CITY OF NORTH RIDGEVILLE

PLANNING COMMISSION

AGENDA

REGULAR MEETING – TUESDAY, JULY 14, 2020

SITE PLAN

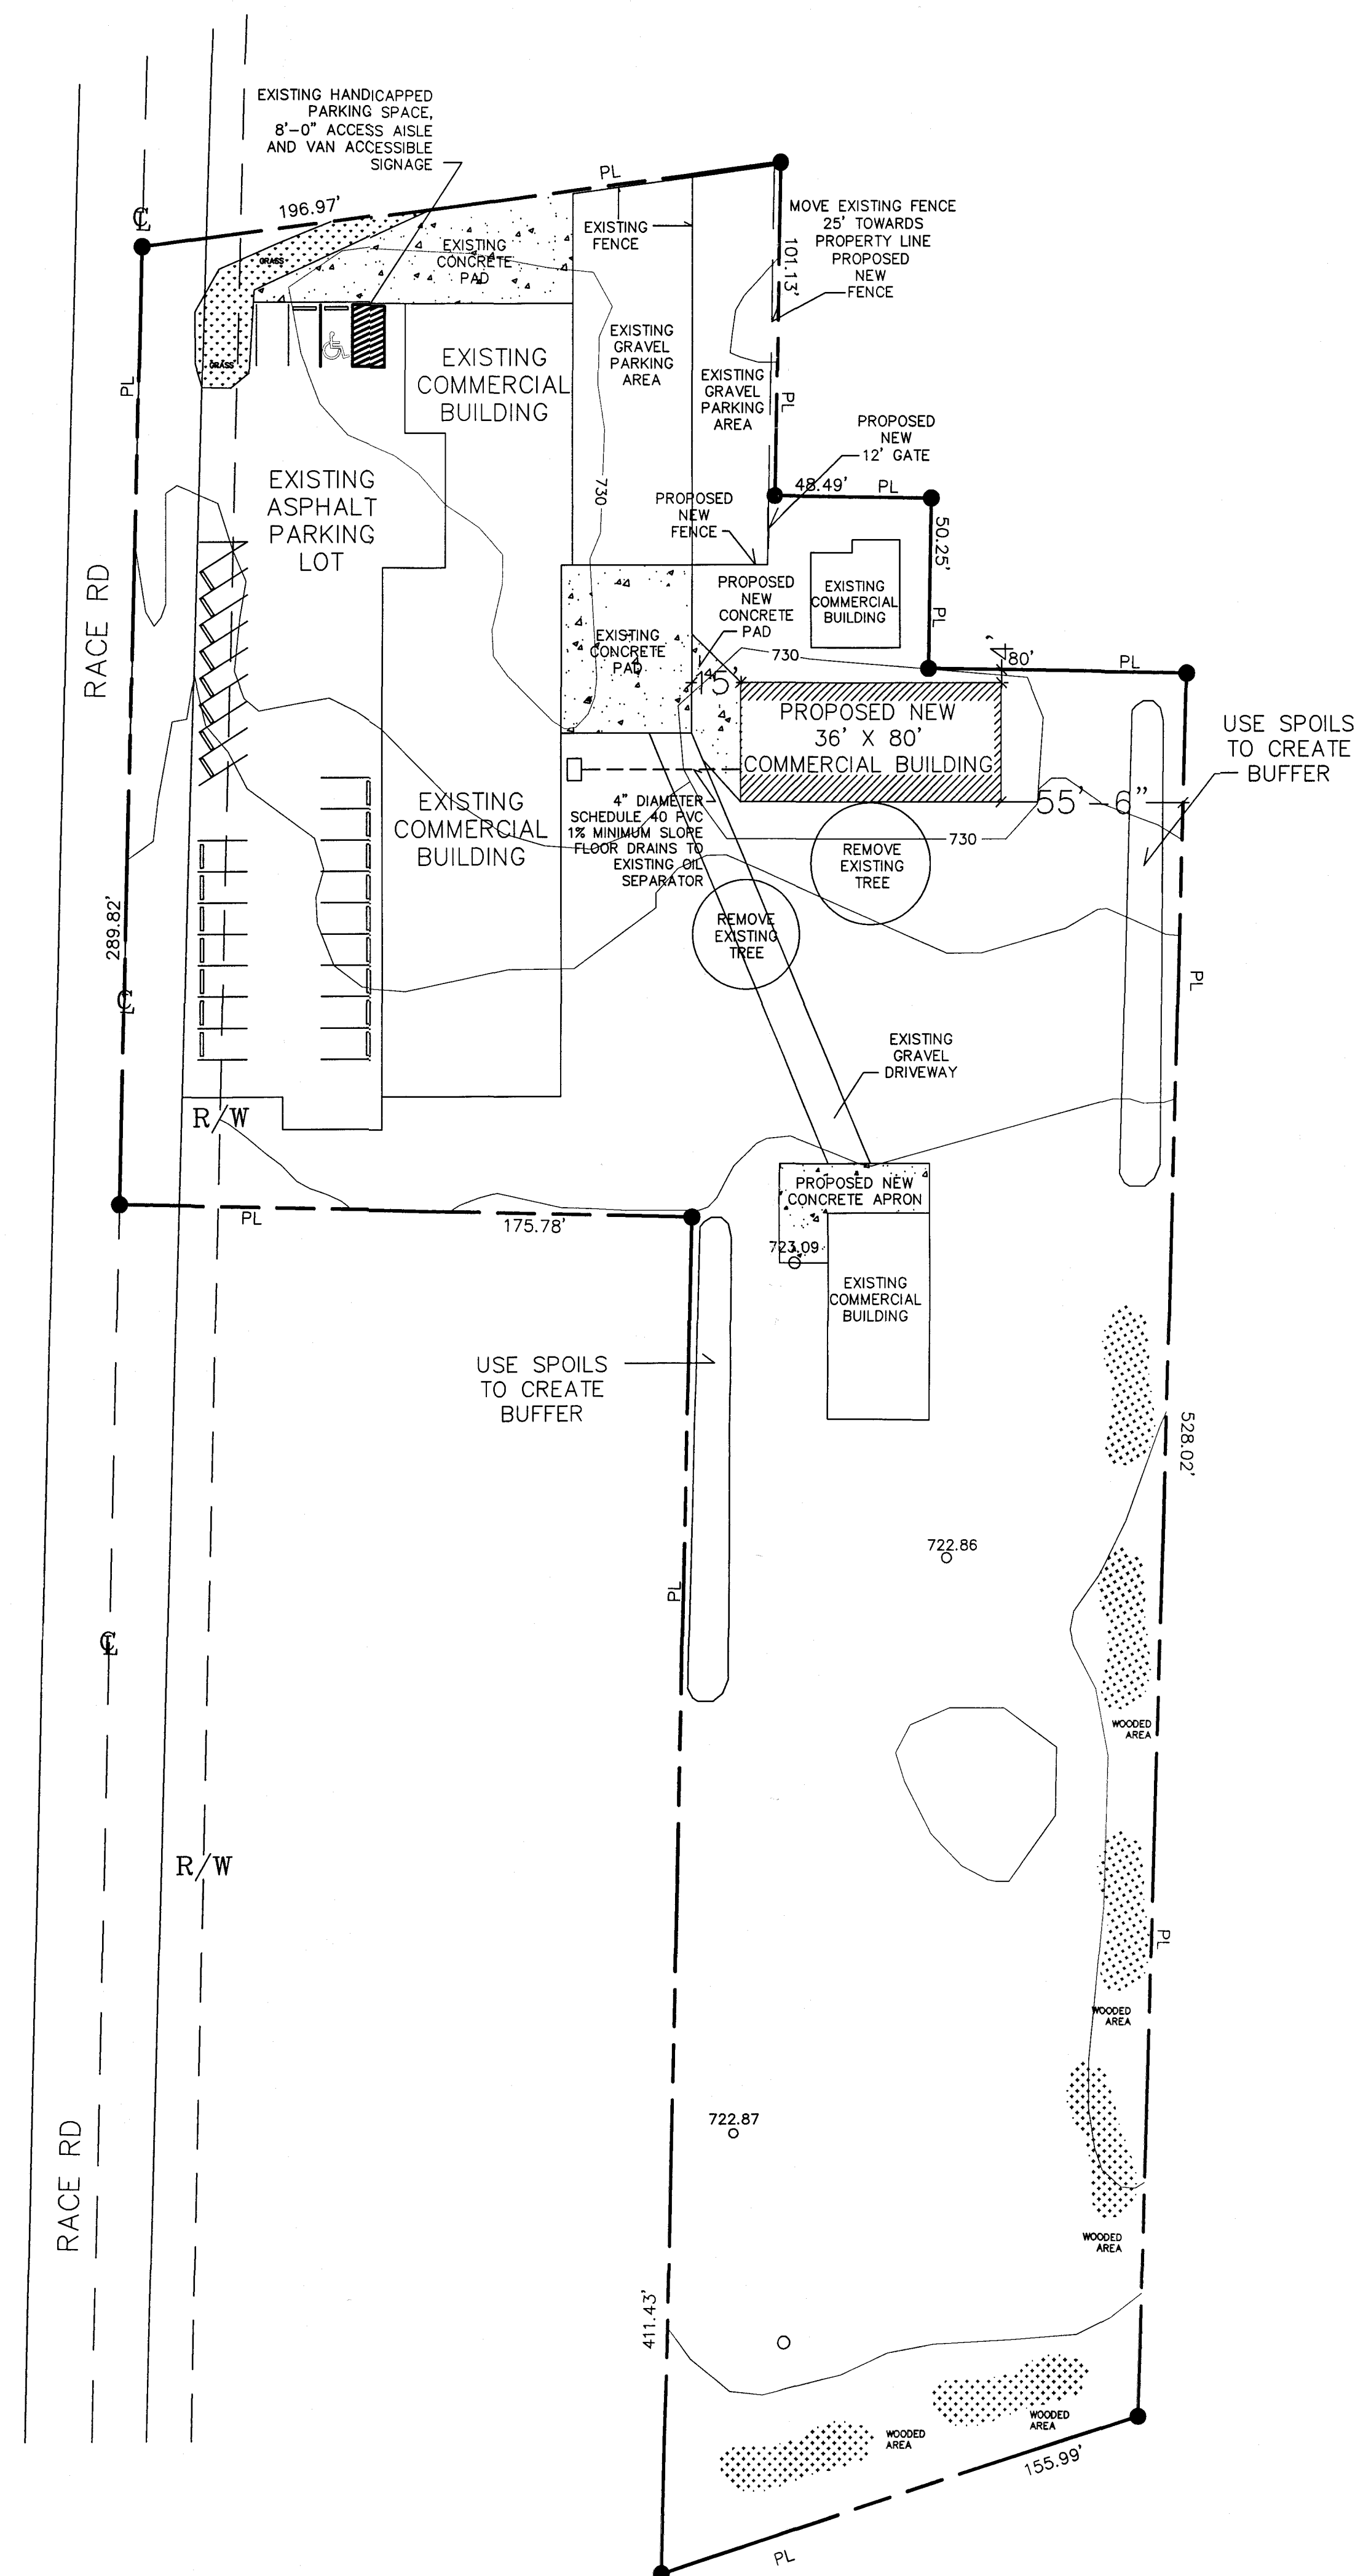
1. !268.04 (b) (3) B. B-3 zoning requires a 25 foot side yard setback. Plans indicate a 4 foot side yard setback. Applicant needs to obtain a variance or move the proposed building to comply with the ordinance.
2. 1288.05 A 10 foot buffer strip is required on the ease property line along the area of the proposed building.
3. Provide sufficient parking for employees and customers.
